ADDENDUM

Job Title
34 POTTER STREET
NORTHWOOD
MIDD

Drawing Title
PROPOSED OUTBUILDING
AND LANDSCAPING
DETAILS

Drg No. 3936 / 02 Rev. KB

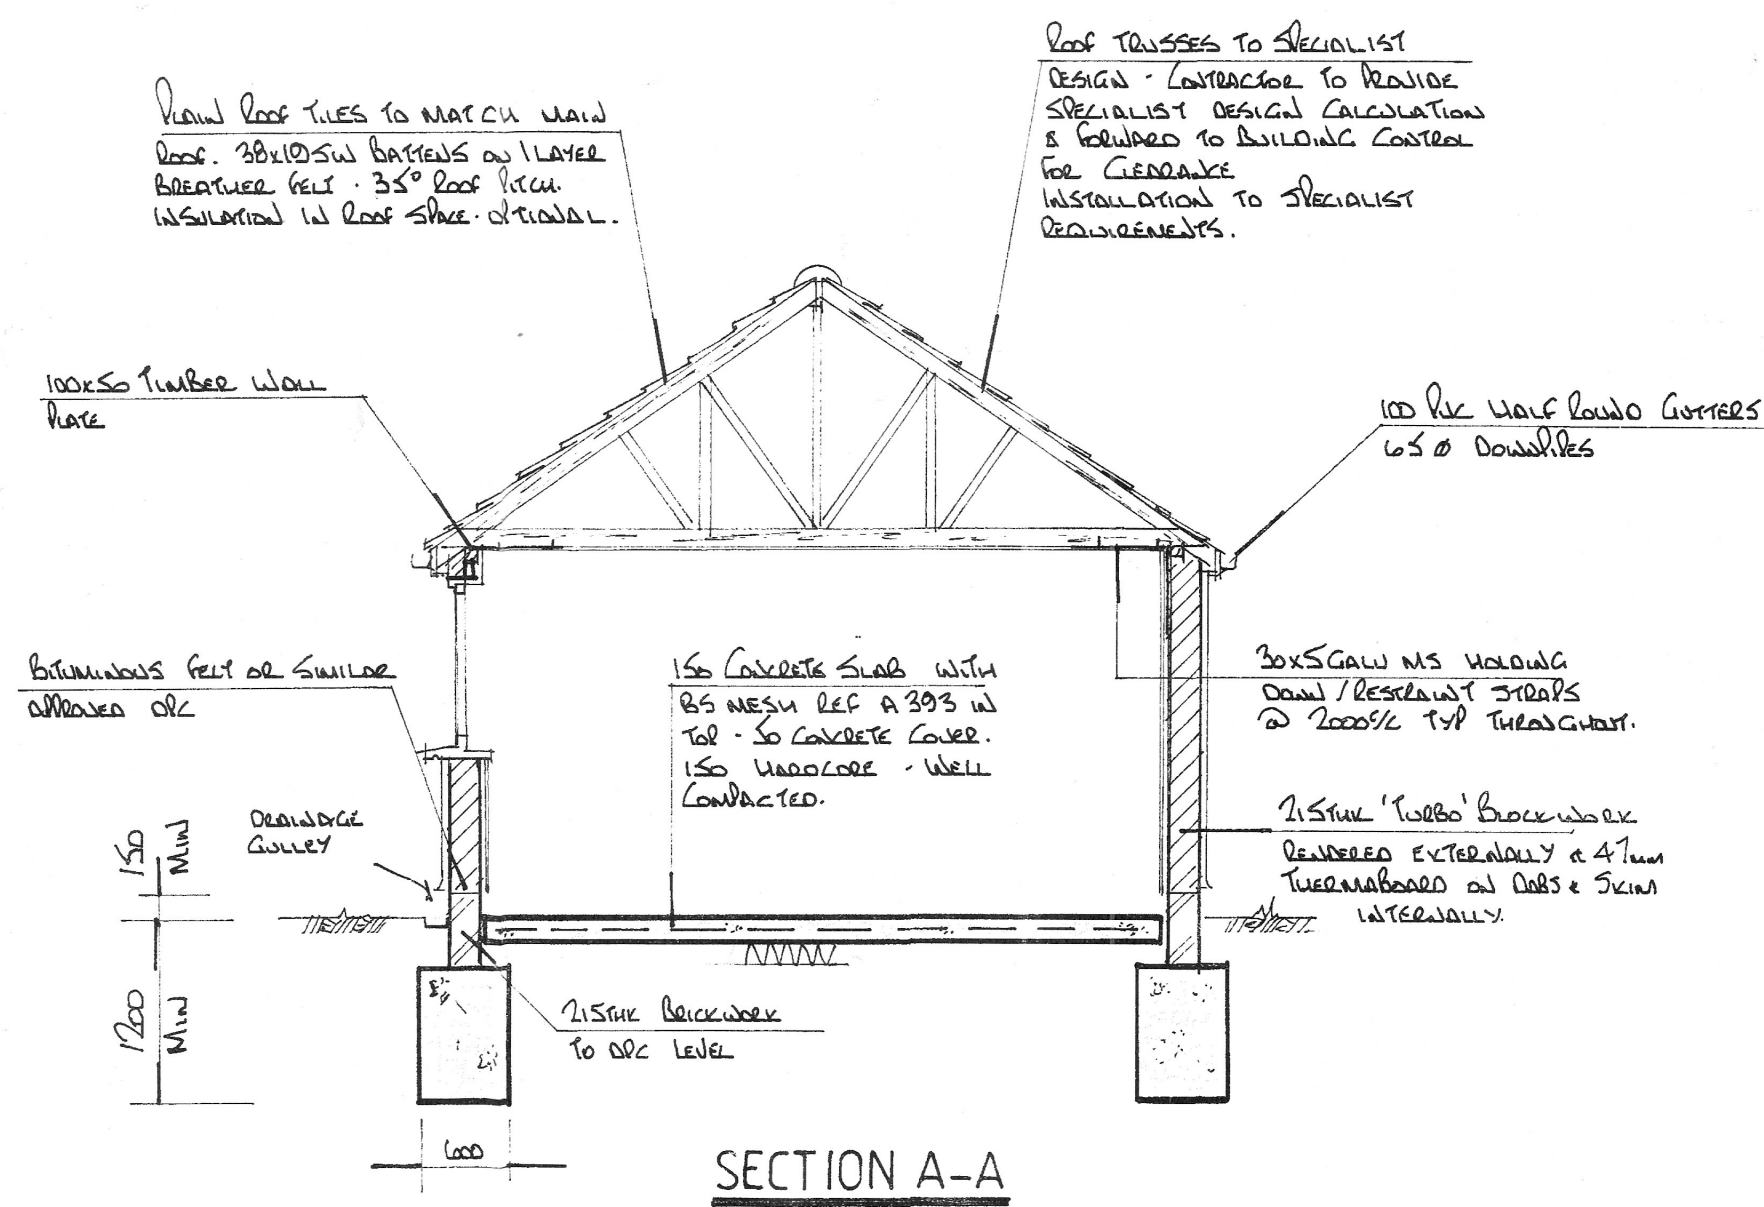
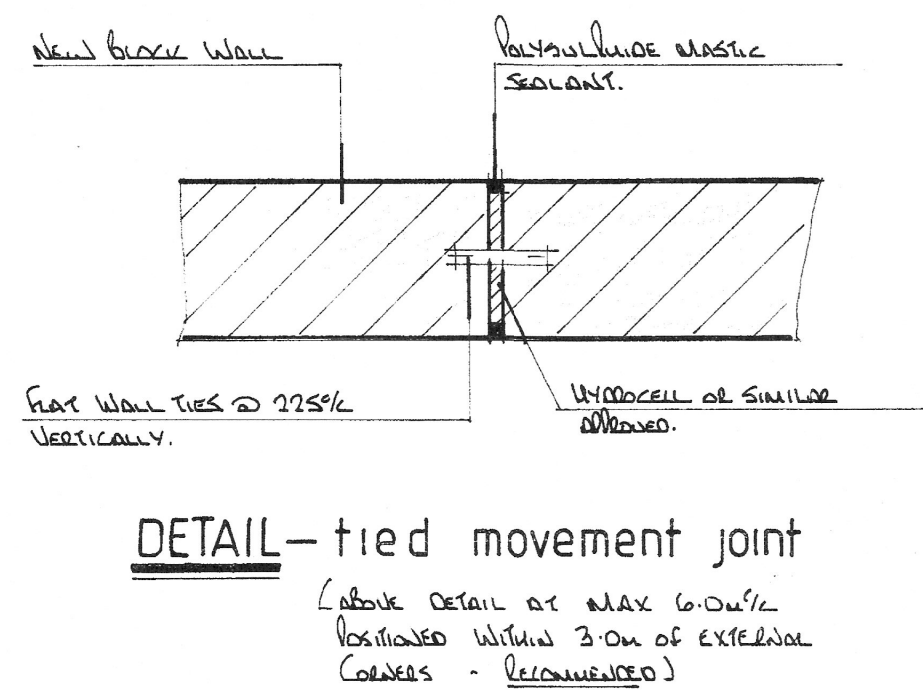
1. MAST HEIGHT = 10M
 2. MAST NOW SHOWN ON FRONT AND SIDE ELEVATIONS.
 3. MAST SUPPORT STAND-OFF BRACKETS = 300MM TO WALL.
 4. MAST EXTERNAL DIMENSIONS 80MM X 80MM X 10M IN GALVANIZED STEEL.
- NB: DRAWING UPDATED FOR FRONT AND SIDE ELEVATIONS ONLY.
5. MAST WILL SUPPORT ANTENNA WITH A ROTARY WASHING LINE PROFILE.
